Access Compliance Report

Public Rights-of-Way

Intersection ID: 32275	Main Street: PRESCOTT_HILL_AV	Cross Street: SPRINGWELL_ST	Location: W
ADA ID: D4BADE1B467A	Ramp Type: Perp	Initial Pass/Fail: Fail	Overall Compliance: No
Severity Score: 12.5			
Codes/Mitigation Info/Possible Solution		Field Measurements/Component Compliance

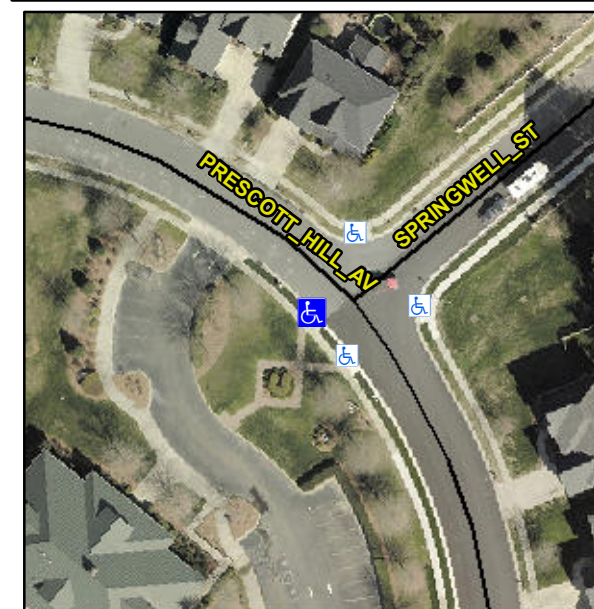
Remove & Replace Entire Ramp.

Not Found, R304.2.2

Compliance	Description	Data	Compliance	Description	Data
N/A	Ramp Length (in)	49.0	No	Ramp Slope (%)	10.0
Yes	Ramp Width (in)	61.0	Yes	Ramp XSlope (%)	1.0
N/A	Flare Type LT	N/A	N/A	Flare Type RT	N/A
N/A	Flare Slope LT (%)	N/A	N/A	Flare Slope RT (%)	N/A
N/A	Flare Traversable LT?	N/A	N/A	Flare Traversable RT?	N/A
N/A	Landing Length (in)	N/A	N/A	DWS Provided?	N/A
N/A	Landing Width (in)	N/A	N/A	DWS Contrast?	N/A
N/A	Landing Slope (%)	N/A	N/A	DWS Length (in)	N/A
N/A	Landing X Slope (%)	N/A	N/A	DWS Full Width?	N/A
N/A	Landing Curb? (Y/N)	N/A	N/A	DWS Offset (in)	N/A
N/A	Shared Landing?	N/A			
N/A	Gutter Ponding?	N/A	N/A	Gutter Slope (%)	N/A
N/A	Gutter Lip Ht (in)	N/A	N/A	Gutter X Slope (%)	N/A
N/A	Painted X Walk1?	No	N/A	Painted X Walk2?	N/A
	X Walk 1 Direction	To N		X Walk 2 Direction	N/A
N/A	X Walk 1 Width (in)	N/A	N/A	X Walk 2 Width (in)	N/A
	X Walk 1 Slope (%)	5.2		X Walk 2 Slope (%)	N/A
	X Walk 1 X Slope (%)	0.6		X Walk 2 X Slope (%)	N/A
